SUBJECT: I.E. Bulletin No. 80-11
Masonry Wall Design

RESPONSE TO ADDITIONAL NRC QUESTIONS

MASONRY WALL DESIGN

PEACH BOTTOM ATOMIC POWER STATION

Figure 1

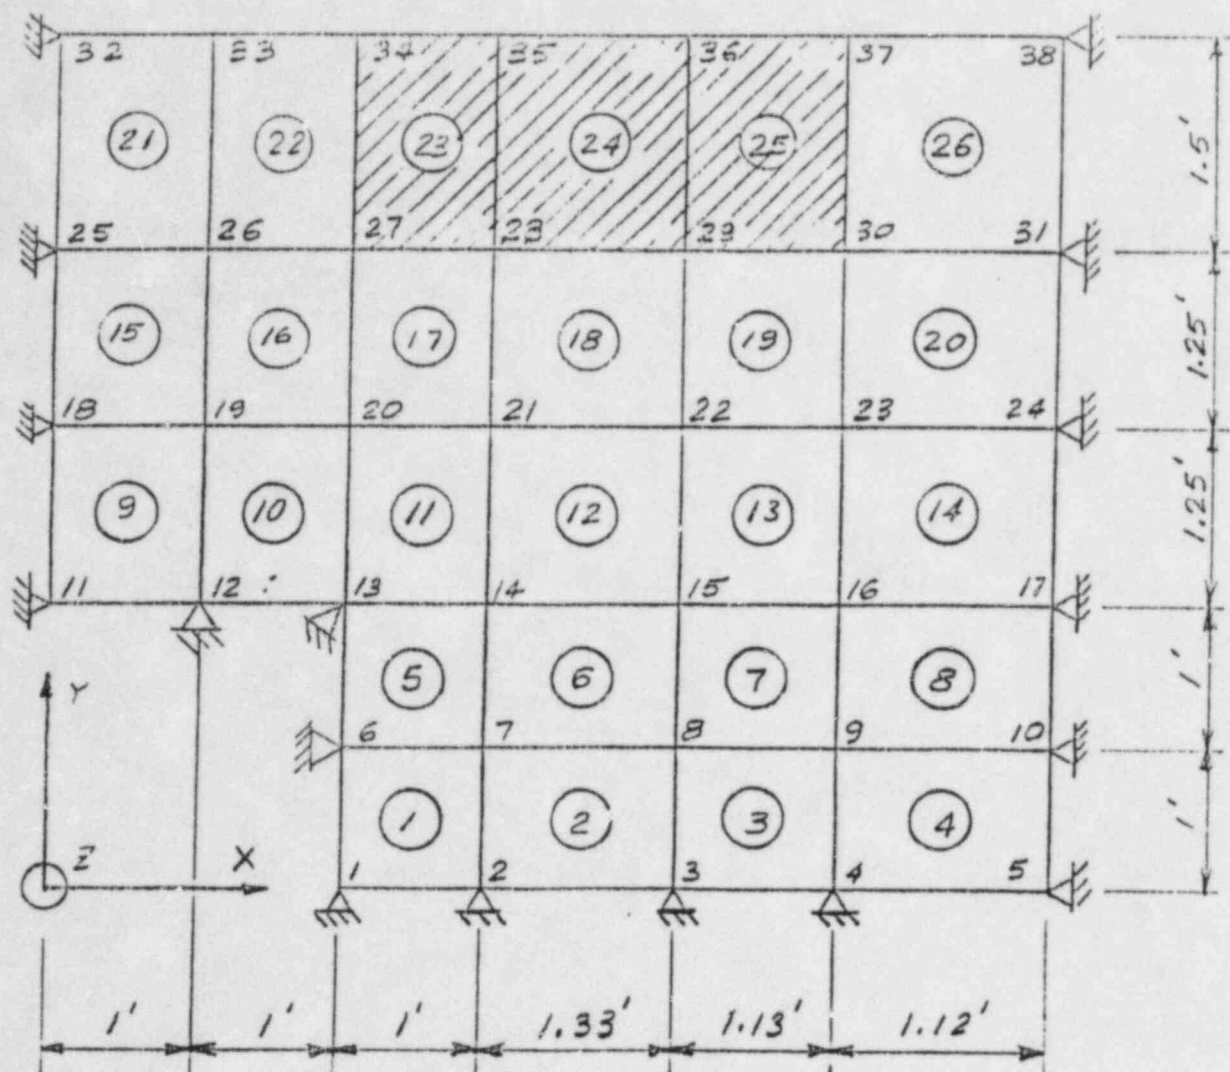
Indicate whether any wall is subjected to tornado load and other impulsive loads (i.e., jet impingement). If so, provide a typical calculation for each case (with necessary explanation to make the calculation understandable).

Some masonry walls at Peach Bottom are subjected to tornado and/or other impulsive loads (i.e., jet impingement). A sample (typical) calculation is attached showing the procedure adopted for the re-evaluation of these walls for tornado and jet impingement loads.

Determine the structural adequacy of a masonry wall subjected to tornado, high energy line break pressurization, and jet impingement loads. The wall is simply supported at the bottom and the sides and is free at the top. In Figure 1, 'Mathematical Model', the cutout portion at the lower left corner is actually a lintel beam passing through and connecting with the wall.

P = Jet impingement loads = 2,454 lbs. acting on an area of 741.3 in.². It is uniformly applied with a factor of 1.25 on elements 23, 24 and 25 of the finite element model in Figure 1

The mathematical model for the finite element computer analysis is shown in Figure 1.

Elements loaded with jet impingement.
Load intensity = $1.25 \times \frac{2454}{741.3} = 4.14 \text{ psi}$
